September 7, 2007

Detroit Metropolitan Wayne County Airport, Detroit, Michigan
Airport Layout Plan (ALP) Review for Runway 3L Extension and End Around Taxiway
Airspace Case No. 2007-AGL-942-NRA

We have completed our review of the ALP filed by Jacobsen & Daniels associates for the Detroit Metropolitan Airport. **We cannot approve** the concept depicted on the ALP at this time. You and your consultants should review the “Results” section of this letter to understand our concerns. The enclosed “General Airspace Comments” provide additional general information to guide future development of the airport.

40:1 DEPARTURE OBSTACLE CLEARANCE SURFACE (1300' SOUTH EXTENSION)

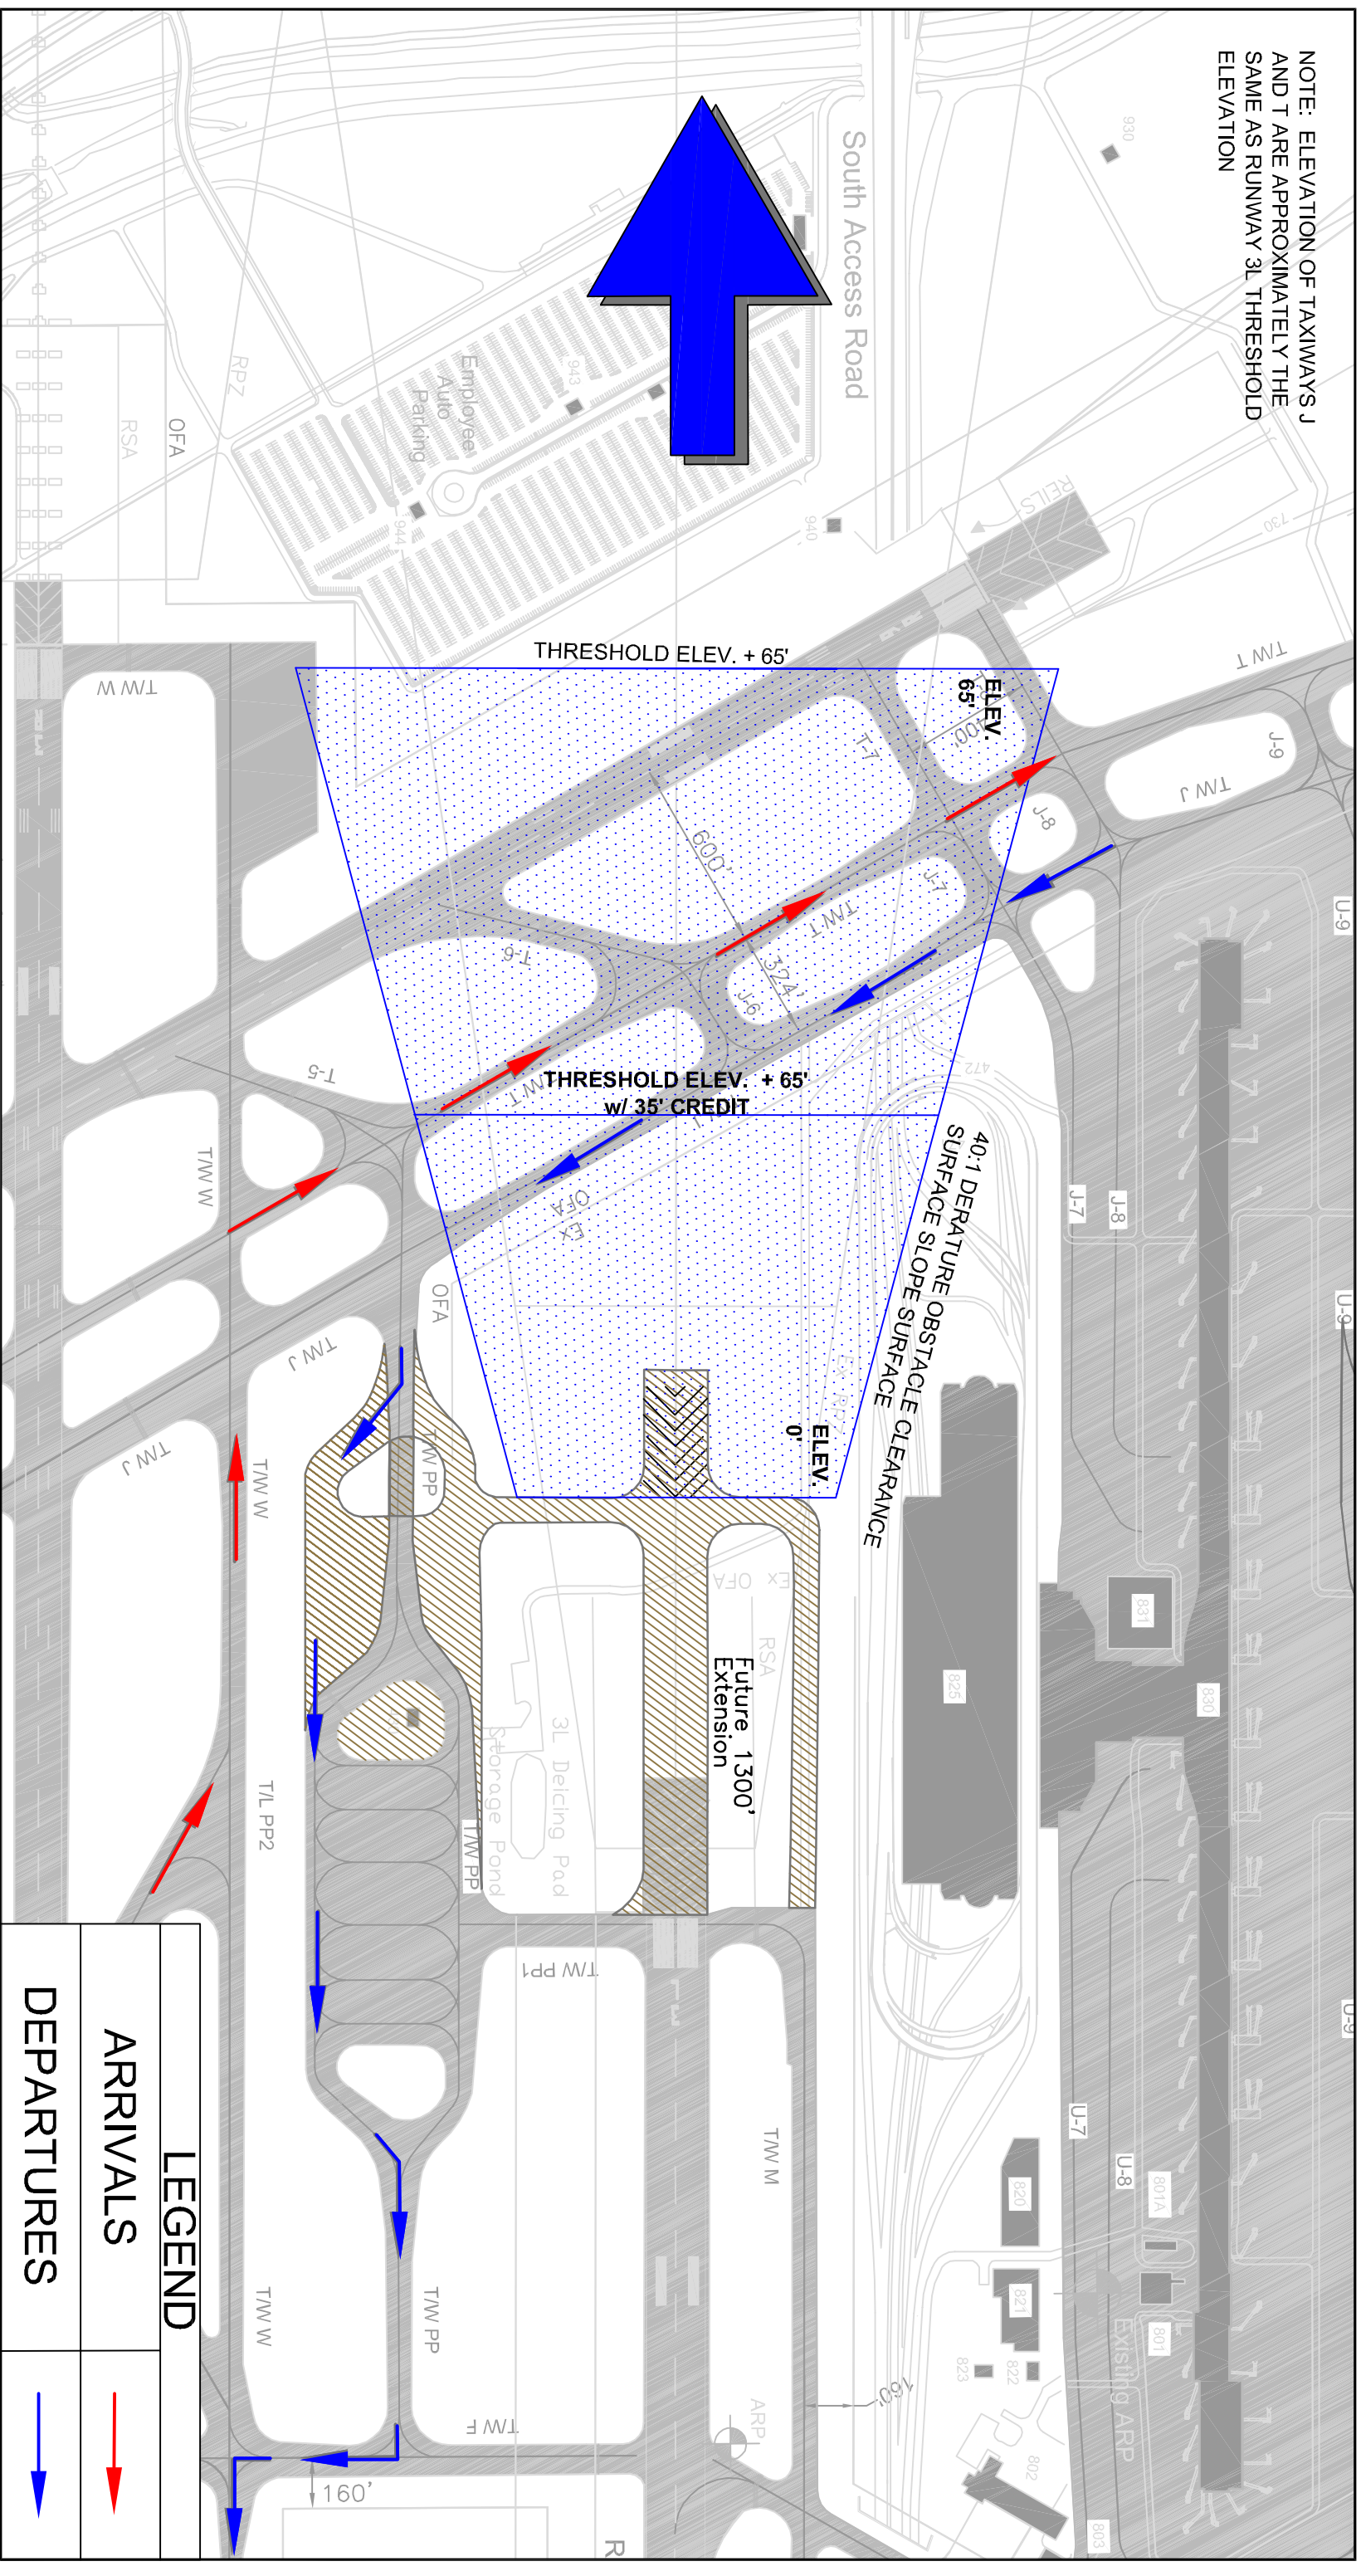
Exhibit 1 of the airspace submittal depicted the plan view of the proposed runway extension and highlights the critical point on the taxi route as the intersection of Taxiway “J” and the 40:1 departure obstacle clearance surface (OCS). Exhibit 1A depicts the

profile view with the design aircraft (B747-400) on the taxiway at this critical point. The tail of the aircraft penetrates the new OCS slope by approximately 44’.

1. The proposed taxi routes would cause a new and deliberate penetration of the OCS. This is not allowable based upon the information presented to date.

2. The 35’ “relief” sometimes discussed, is no longer available for Instrument Flight Rules (IFR) departures. For objects that penetrate the 40:1 departure surface and result in an increased climb gradient to an altitude less than 200’ above the Departure End of Runway (DER) elevation, the proposed action would be to add a take off note that would be published in the US Terminal Procedure book.

3. How will pilots departing Runway 21R at night, be able to differentiate aircraft on taxiway between “J” and aircraft at the end of Runway 21R?
4. Per paragraph 415 of AC 150/5300-13, change 12, “*Airport Design*”, AAS-100 must pre-approve any proposed development using End Around Taxiways (EATs), such as this. In order for them to provide comments, additional study will be required. At a minimum the airport sponsor must provide the capacity benefits and cost of the proposal.

One way to avoid these concerns is not to taxi aircraft on taxiway “J” when Runway 21R is being used for departures. However, if this is proposed, additional coordination and study will be required, to determine the impacts on capacity at the airport. We recommend that the airport sponsor study an extension to the North. This could be

40:1 DEPARTURE OBSTACLE CLEARANCE SURFACE (1300' SOUTH EXTENSION)

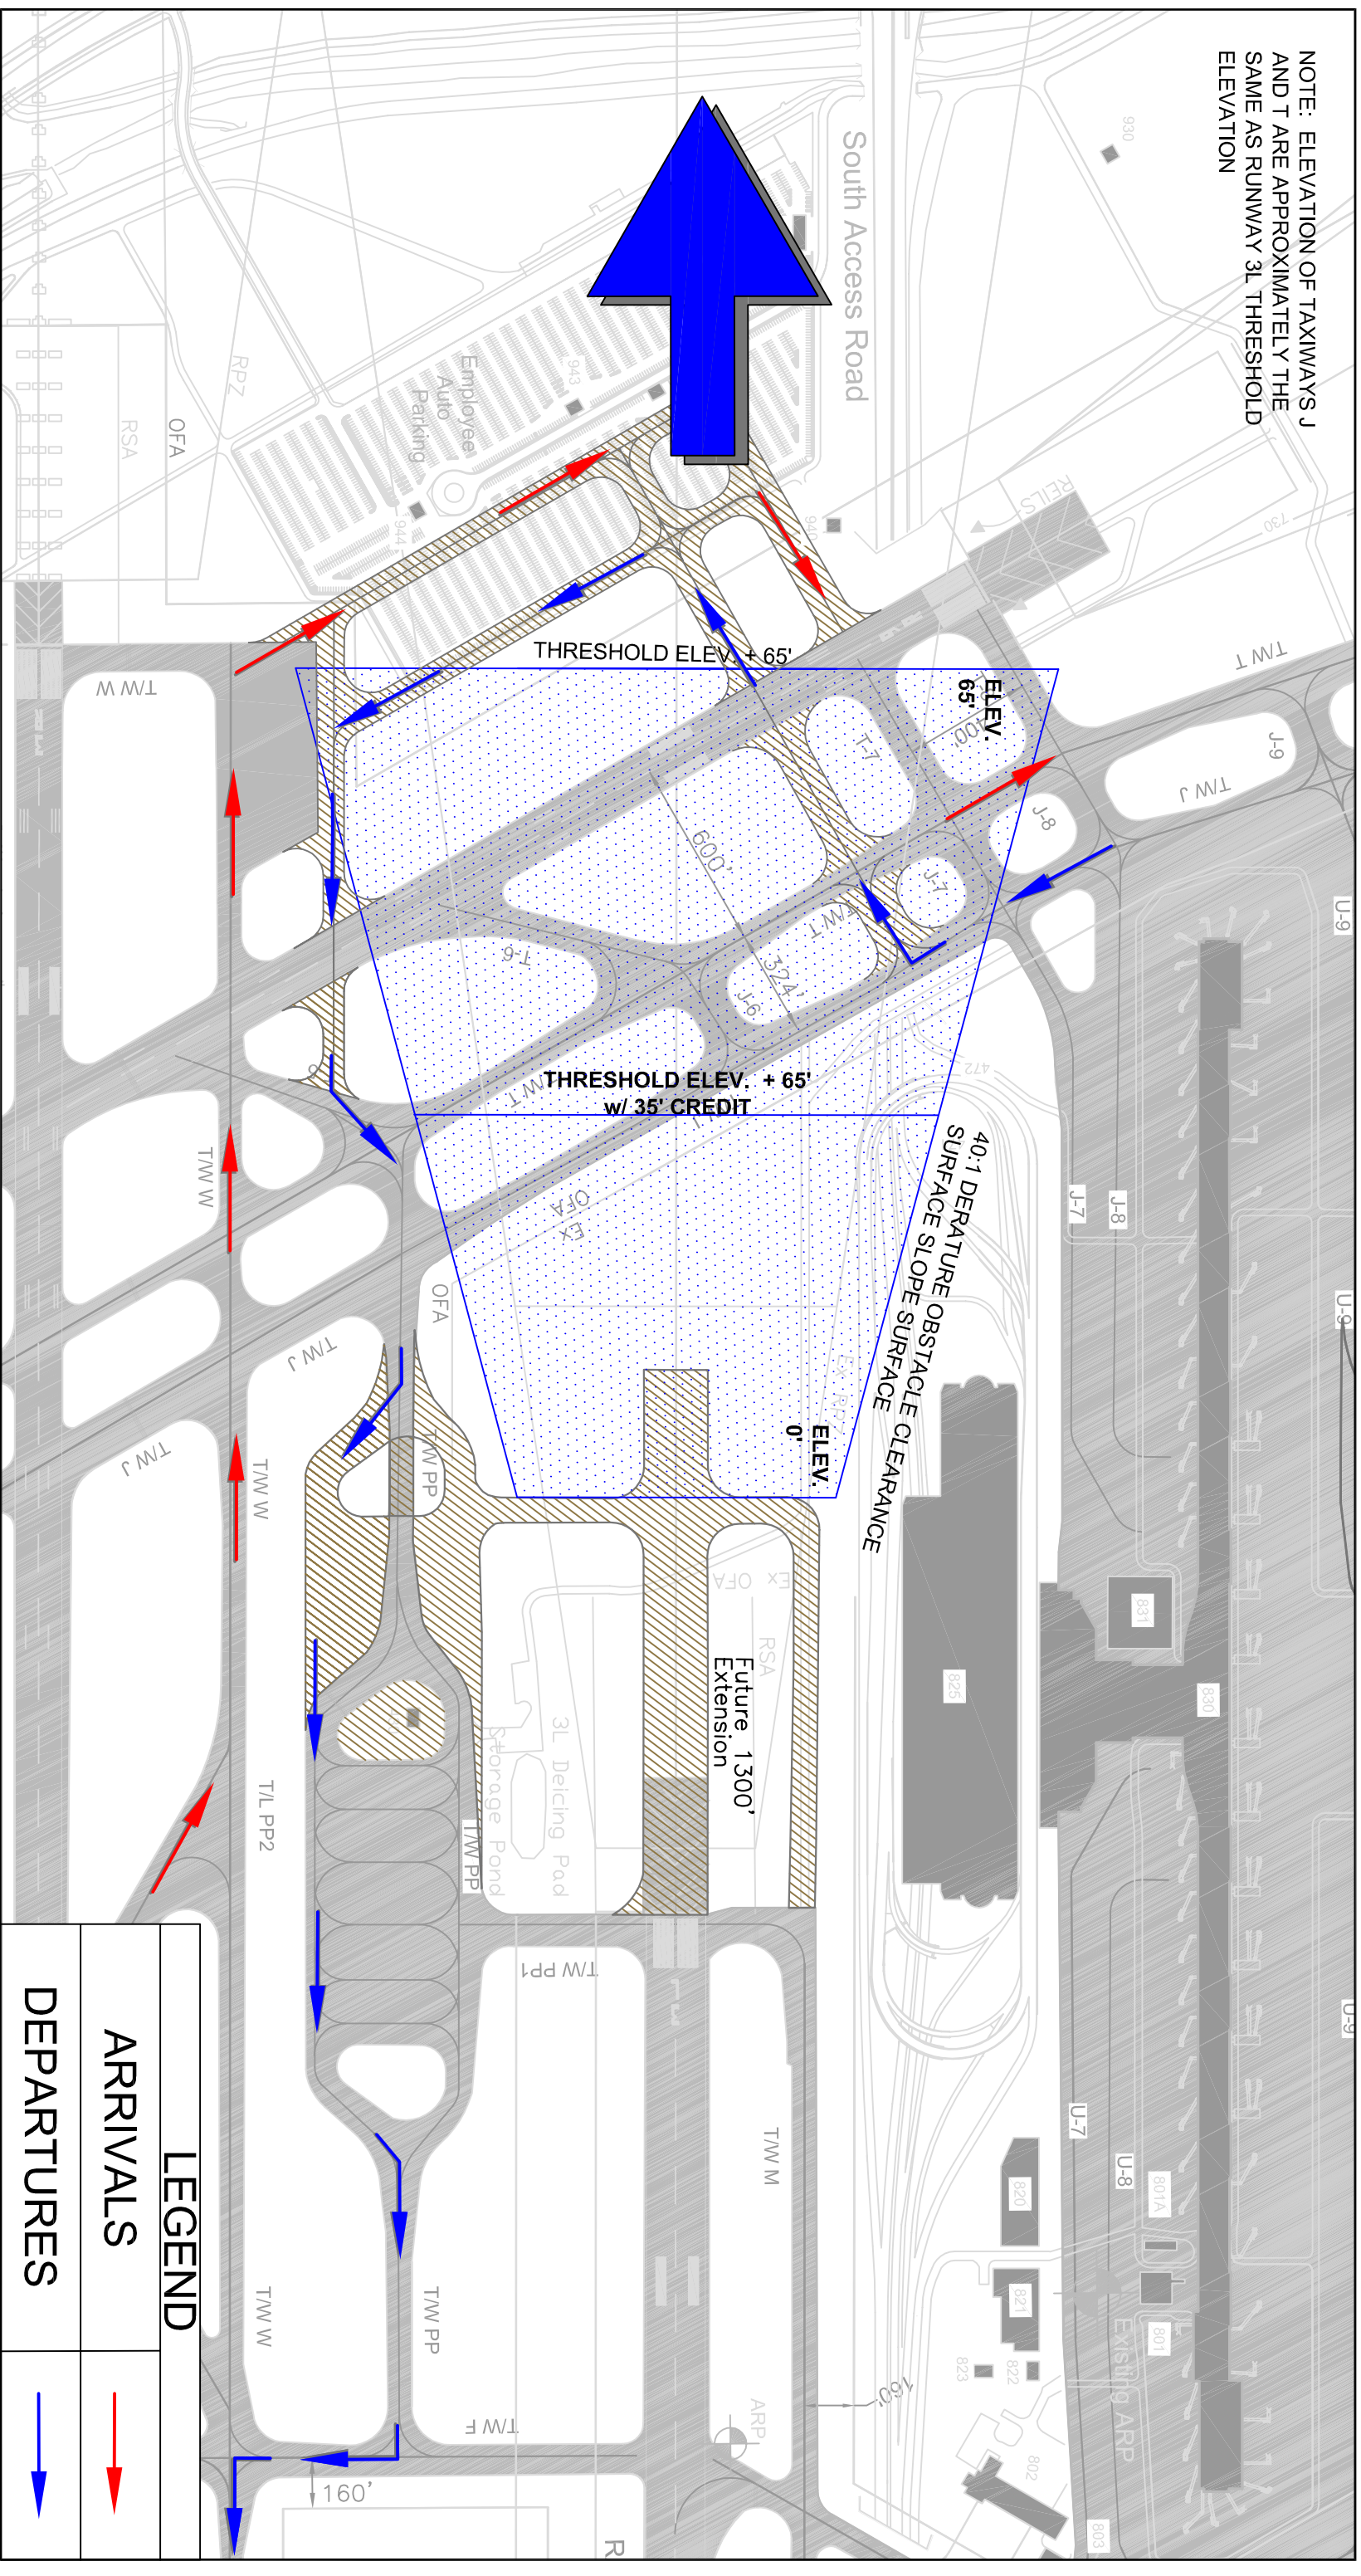
Exhibit 2 of the airspace submittal depicts an expensive but feasible taxiway system improvement that provides additional distance between the taxiway and the end of runway extension. However, there still is a critical point for these aircraft as they taxi back to the Northwest Terminal Complex. Exhibit 2A depicts the profile view with the design aircraft (B747-400) on the taxiway at this critical point. The tail of the aircraft penetrates the new OCS slope by approximately 23’.
